NUREG-0191

environmental statement

LACROSSE BOILING WATER REACTOR DAIRYLAND POWER COOPERATIVE

APRIL 1980

Fig. 3.4-2. River-Water Use. (From Environmental Report Comments and Responses.)

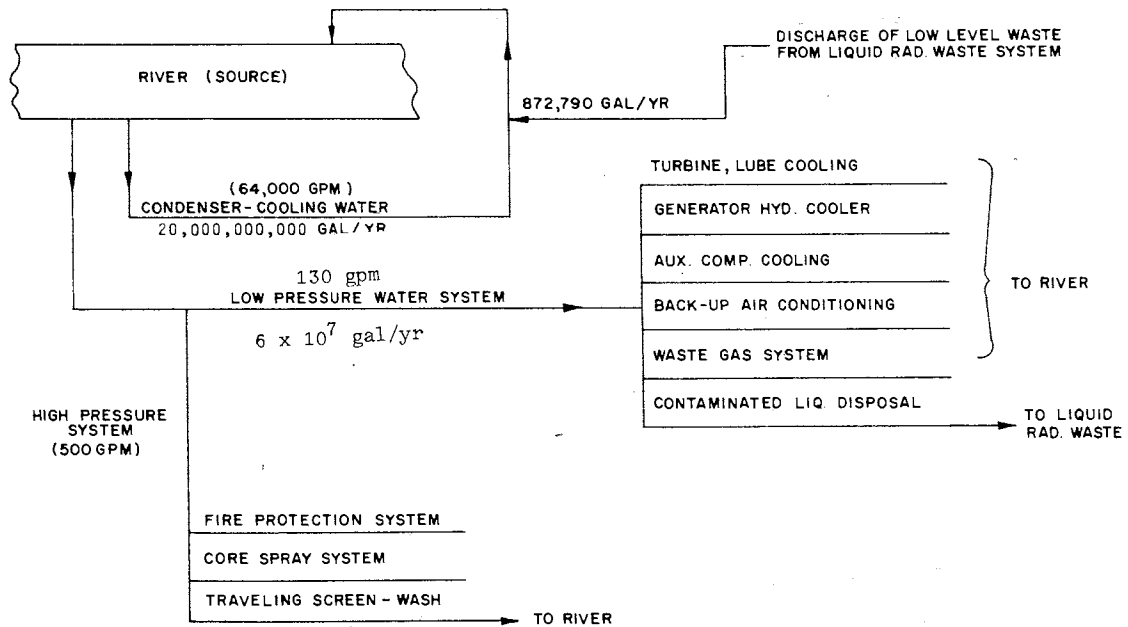
In sections 3.6.2.1 and 3.6.2.2 of the draft statement, it is stated that approximately 1100 gpd of waste will be collected in the containment building collection subsystem and 700 gpd in the turbine building collection system, Figure 3.4-2 indicates a daily release of 2390 gpd; the additional 590 gpd should be identified as to its source in Figure 3.6-1, Liquid Waste Treatment System.

Fig. 3.6-1. Liquid Waste Treatment System.

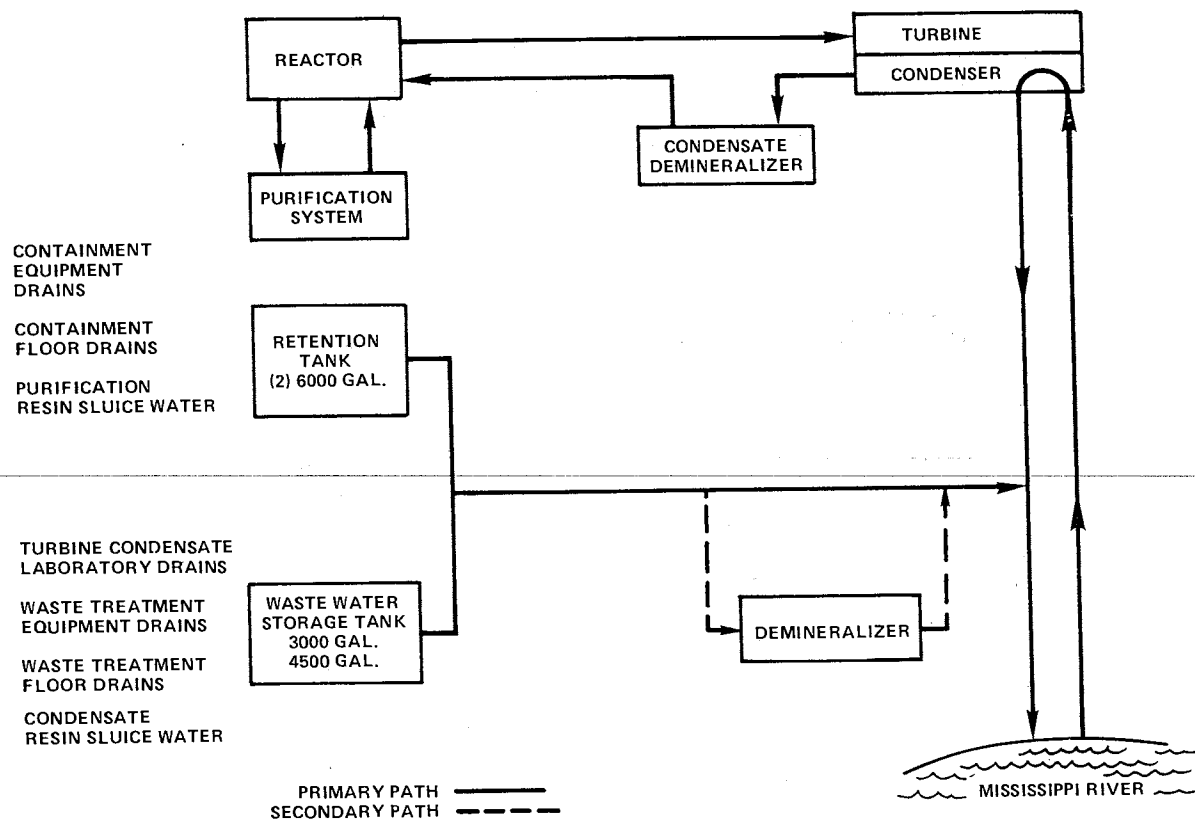
It is then stated that the reason that the actual discharges are higher than those estimated by the staff is the licensee's "under-utilization of the installed processing facilities." According to Figure 3.6-1, Liquid Waste Treatment System, these installed processing facilities consist of a 1 gpm evaporator in series with a polishing demineralizer. Since treatment with the installed equipment will not have much effect on the release of tritium, the EPA believes actual releases will probably average 115 Ci/yr (approximately the average of the last four years) rather than 90 Ci/yr. It is recommended that the final statement be so revised. Also, the reduction in the release of corrosion products and mixed fission products, exclusive of dissolved gases, (CP & MFP), seems predicated on the assumption that the liquid waste treatment system as shown in Figure 3.6-1 is capable of processing all wastes prior to discharge. Using the value of 872,180 gal/yr of liquid waste discharged from the liquid radwaste system given in Figure 3.4-2, River Water Use, as the quantity of liquid waste processed annually by the system, it becomes apparent that on a continuous mode basis, this 1 gpm system would have to be able to process waste at a rate beyond its capability, 1.7 gpm to achieve the releases predicted in the draft statement. It is recommended that the section be revised to indicate a higher estimate of CP & MFP release or the modifications, along with the cost benefit analysis, which will be required of the system.

Fig. 5.3-1. Water Temperature Zones. (From the ER.)

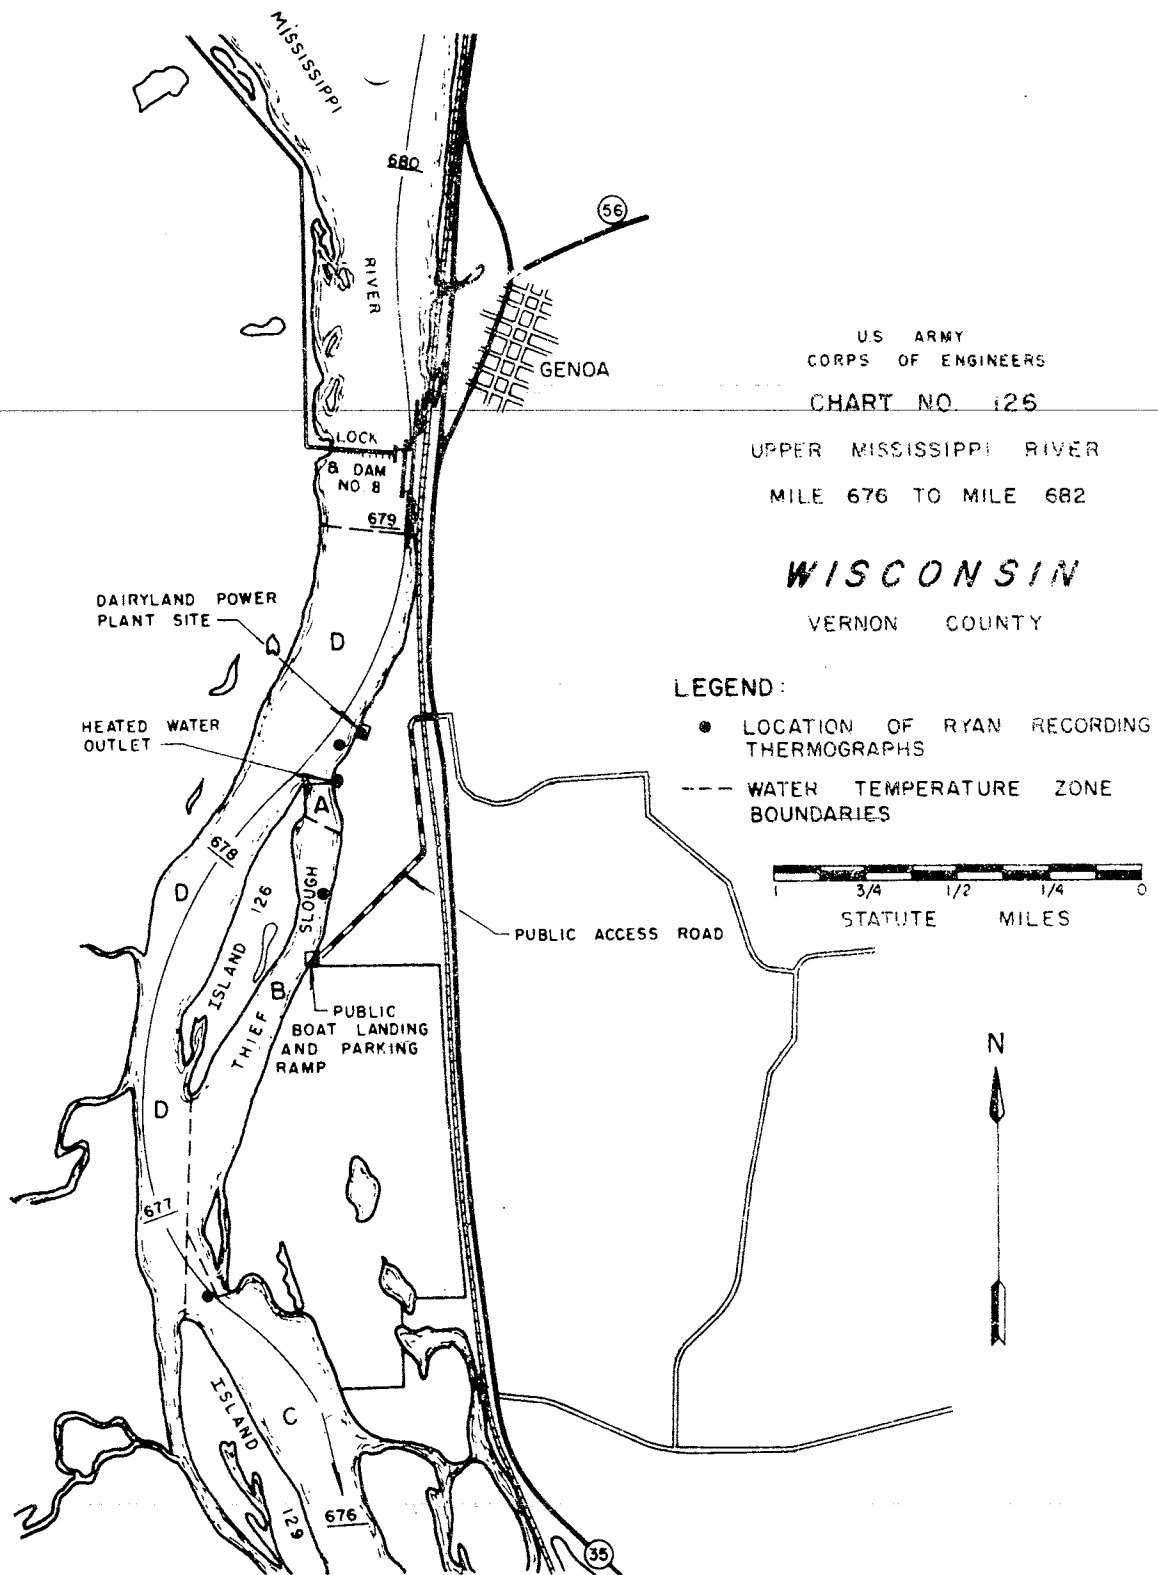
Figures 2.5-1 and 5.3-1 need scales in order to make them useful for impact evaluation. Specific locations of wells rather than merely a bracketed interval should be shown in figure 2.5-1.
